Ordinary Meeting of Council

Wednesday 14 August 2024 6pm

C2408-1 FINAL APPROVAL OF LOCAL DEVELOPMENT PLAN – LOTS 72 AND 25, 2-4 CLONTARF ROAD, AND LOT 73, 1 NAYLOR STREET, BEACONSFIELD.....	3
1. Minute of Planning Committee item PC2310-1, 4 October.....	3

PC2310-1 CLONTARF ROAD, NO. 2 (LOT 72) AND 4 (LOT 25) AND NAYLOR STREET NO.1 (LOT 73), BEACONSFIELD – 162 LOT FREEHOLD SUBDIVISION – (JL WAPC163666)

Figure 1 – The Heart of Beaconsfield Masterplan connectivity image

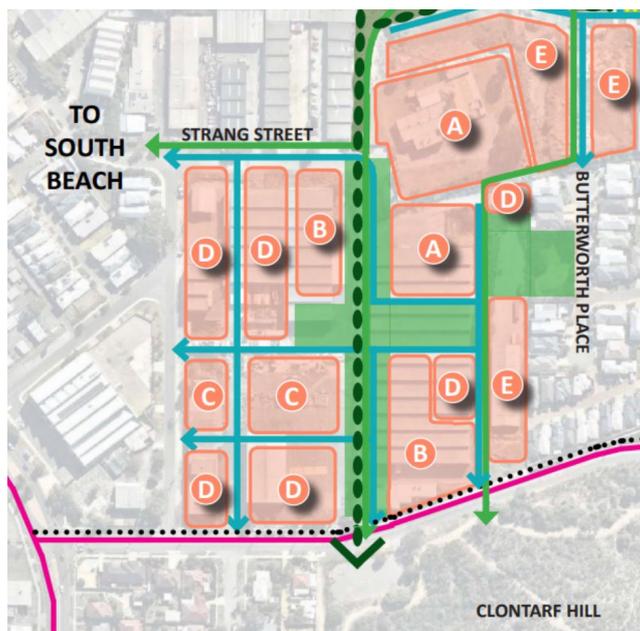
The Lefroy Road Quarry Structure Plan proposes nearly 40% of its area as public open space and the Structure Plan identifies a potential pedestrian linkage at 2 Strang Street (WA Portuguese Club site) between the open space of the Structure Plan area and DA14, exiting above 1 Naylor Street and 4 Clontarf Road. A connection between the Lefroy Road Quarry and Clontarf Hill is also identified in the City's Green Plan (2001) as a potential green space and link, connecting two areas of substantial open space at the Lefroy Road Quarry site and Clontarf Hill whilst providing a high standard of pedestrian connectivity and amenity between existing and future residential land uses. The Green Plan also highlights the important linkage this connection would provide to adjacent open space to the south of Clontarf Hill within the City of Cockburn. This connection is further identified in the Heart of Beaconsfield Master Plan.

The line of connectivity is to be located parallel to Naylor Street, at the common boundaries of 1 Naylor Street, 2 Clontarf Road and 4 Clontarf Road, exiting at Clontarf Road opposite the Clontarf Hill car park. Officers consider the requirement of a pedestrian linkage at this location as appropriate as one of the prerequisites for approving development at the significantly higher density and greater building height provided as part of this amendment. Additionally, this linkage, in conjunction with the pedestrian linkage proposed at 2 Strang Street, will provide a high level of connectivity between significant areas of public open space and amenity benefits (social, environmental and health) to both existing and future residents of the locality.

Figure 2 – Schedule 7 – Sub Area 4.3.5 – map

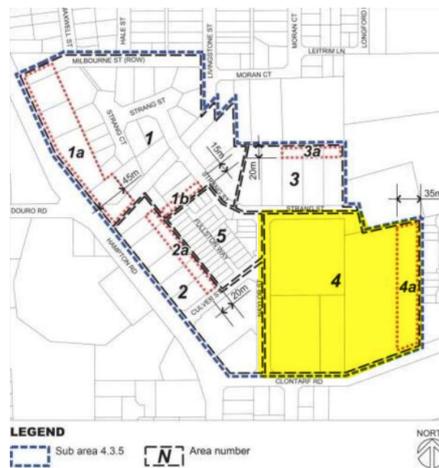
The subject site falls within sub area 4.3.5 in Schedule 7 of LPS4 and has a R25 density coding under the Scheme map. See Figure 2 below showing excerpt from LPS4 schedule 7 – showing the site highlighted in yellow.

In 2015 Council adopted Scheme Amendment 43 which introduced the additional development standards to Schedule 7 of LPS4 and fragmented the area into development areas. See map below:
